RE: KAFB draft Permit  
Public Notice Number 07-03  
EPA ID No. NM9570024423

Please accept the following comments on the subject Draft Hazardous Waste Permit. Our comments relate to the proposed treatment of the existing 21-inch Tijeras Phase II Interceptor (Interceptor) that crosses KAFB Landfill 2 (LF-002). Paragraph 5.2.4 of the Draft Facility Operating Permit dated April 16, 2007 states "The sanitary sewer line that passes through LF-002 shall be removed in accordance with the Department's instructions (letters from NMED to Carl Lanz: July 16, 2004; September 13, 2004; and March 10, 2005). The NMED approval letter dated September 13, 2004 for the Corrective Measures Design and Implementation Work Plan states "The Tijeras Sewer Interceptor shall be rerouted such that no active portion of the pipeline remains within or is located within 100 (one hundred) feet of the landfill. The abandoned portion of the Tijeras Sewer Interceptor shall be drained; its contents disposed of in a manner that meets all applicable laws and regulations."

# EXCERPT FROM RECORD DRAWINGS

**SANITARY LANDFILL CROSSING DETAIL**

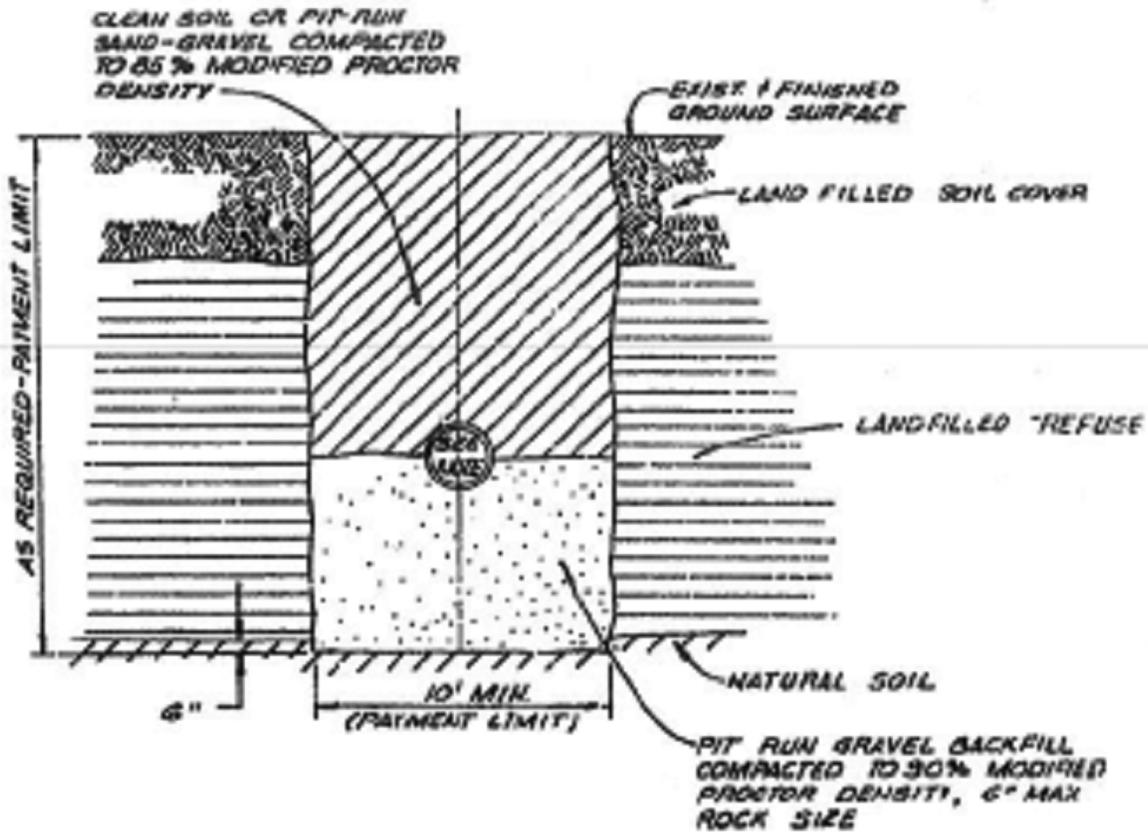
4. The Interceptor pipe material and construction methods are the best available.
- a. The landfill was recognized at the time of design and the design accounted for the landfill.

- i. The trench removed and disposed of the landfill under the pipe and to each side. This removal was made below the bottom of the landfill. See the attached excerpt from the record drawing.

- ii. High quality bedding was provided that will provide a high degree of support to the installed pipe. As verified through video inspections, settling of the pipe is not noted, confirming the high quality of construction.
